PATENT NO. 2,300,818  
ISSUED: April 13<sup>th</sup> 2004  
FILED: August 31<sup>st</sup> 1999  
PRIORITY: September 15<sup>th</sup> 1998  
FOR: ROTARY MOWER CONDITIONER HAVING IMPROVED  
CUT CROP FLOW  
OWNER: HAY & FORAGE INDUSTRIES

**REMARKS OF REQUESTER ON RE-EXAMINATION OF A PATENT UNDER  
SECTION 48.1(1) OF THE PATENT ACT**

FIG. A

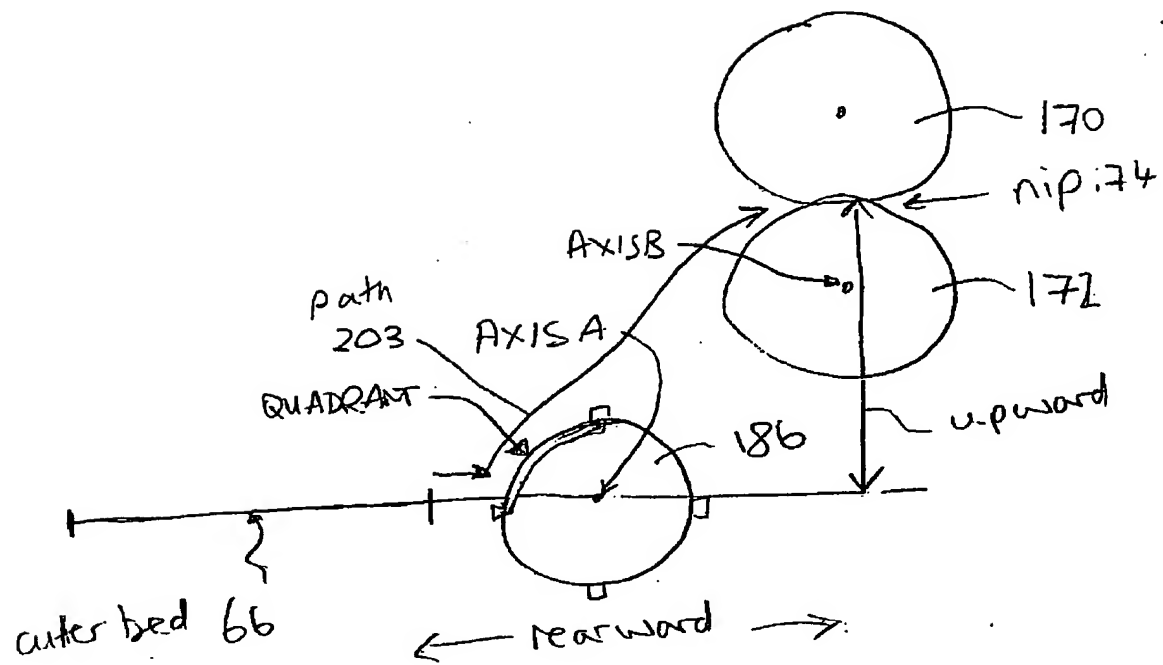
Turning therefore to a proper analysis of exactly what is disclosed in the description, reference is made to the attached Figure A which has been developed with reference only to the description.

These sentences merely state that the axis, indicated in Figure A at axis A, of the roller 186 is below axis B of the roller 172. The second sentence defines an upper front quadrant marked on Figure A of the roller 186 and states that it presents an upwardly and rearwardly moving surface extending between the cutter bed 66 and the nip 174. This quadrant is marked at "quadrant" in Figure A and it is shown generally extending between the cutter bed 66 and the nip 174.

These conditions are marked on figure A by the path or arrow 203.

It will be noted therefore that the description is entirely silent as to the height of the bottom conditioning roll 172 relative to the guide roller 186 and in relation to the position of the quadrant of the roller 186 relative to any part of the bottom

conditioning roller 172. Thus the arrangement illustrated in Figure A attached hereto is entirely consistent with the complete description of the patent.

There is no support in the description therefore for the above quoted limitation that the quadrant is in front of the lower forward peripheral portion of the lower conditioning roller 172.

Attached as Figure B is an enlarged view of a part of Figure 10 of Savoie on which is marked those items which correspond to the conditioning rollers 170 and

172 together with the nip 174. Also is marked the cutting zone generally indicated at 66. Also is marked the conveying roller 186. The conveying roller has a quadrant which is marked as such on Figure B and commences of course at a plane A which passes through the axis A of the roller 186. This quadrant terminates at a position vertically aligned with the axis A. Also is marked the forward lower portion of the lower roller 172 which is marked at lower portion and extends from a line in plane B which is aligned with the axis B of the roller 172 and extends to a bottom position which is vertically aligned with axis B.

As set forth above, therefore, based upon the first of the available interpretations of the meaning of the words "in front of", the roller 186 is clearly in advance of the conditioning roll 172 bearing in mind movement of the construction in the direction toward the left in Figure B. In addition careful comparison of the quadrant in relation to the lower portion will show that a part of the quadrant is located in alignment with a part of the lower portion. Thus, even in accordance with the second interpretation of the term "in front of", Savoie anticipates this feature. As set forth hereinbefore, there is no basis in the description for an interpretation of the words "in front of" to mean that the whole of the quadrant is directly aligned with the whole of the lower portion. This cannot therefore be a proper interpretation of the words "in front of".

Thus it is clear that Savoie anticipates any proper interpretation of the feature now added into Claims 1, 13 and 25. Thus these claims remain anticipated by the prior art of Savoie.

Referring again to Figure B presented herein, on which the reference numerals from the present patent have been added to Figure 10 of Savoie for convenience of review, it is clear that Savoie discloses a conveying roller 186 which has an upwardly and rearwardly moving portion at least partly in front of a lower portion of the bottom roll 172.
